Project No. 207-12082

SOUTH SIDE  
SUBSTATION  
SINGLE LINE DIAGRAM

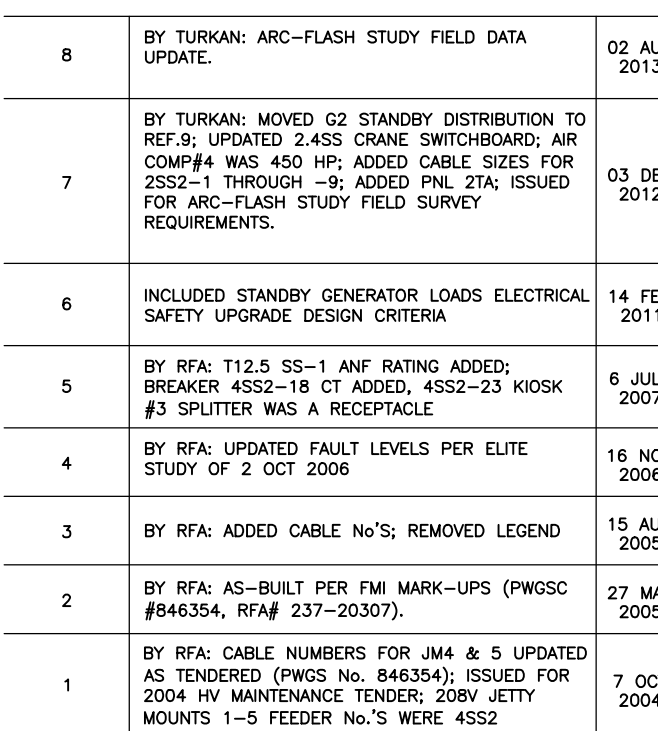
1. VERIFY INTERNAL DISTRIBUTION.
2. (NOT USED).
3. VERIFY CT. RATIO.
4. VERIFY I.C. RATING OF 52-4SS1-3.
5. VERIFY P.T. SOURCE.
6. INVESTIGATE IF SWITCH RATING IS ADEQUATE.
7. VERIFY 2 OR 3 CT'S.
8. (NOT USED).
9. CHANGE NAMEPLATE.
10. (NOT USED).
11. FIELD VERIFY CONDUIT SIZES.
12. CONFIRM METER NUMBERS AND IDENTIFY BREAKER.
13. (NOT USED).
14. VERIFY IF SPARES ARE CONNECTED TO SECTION #3 BUS OR THE MAIN BUS.
15. VERIFY CONNECTION.
16. UPGRADE BREAKER FOR I.C. RATING.
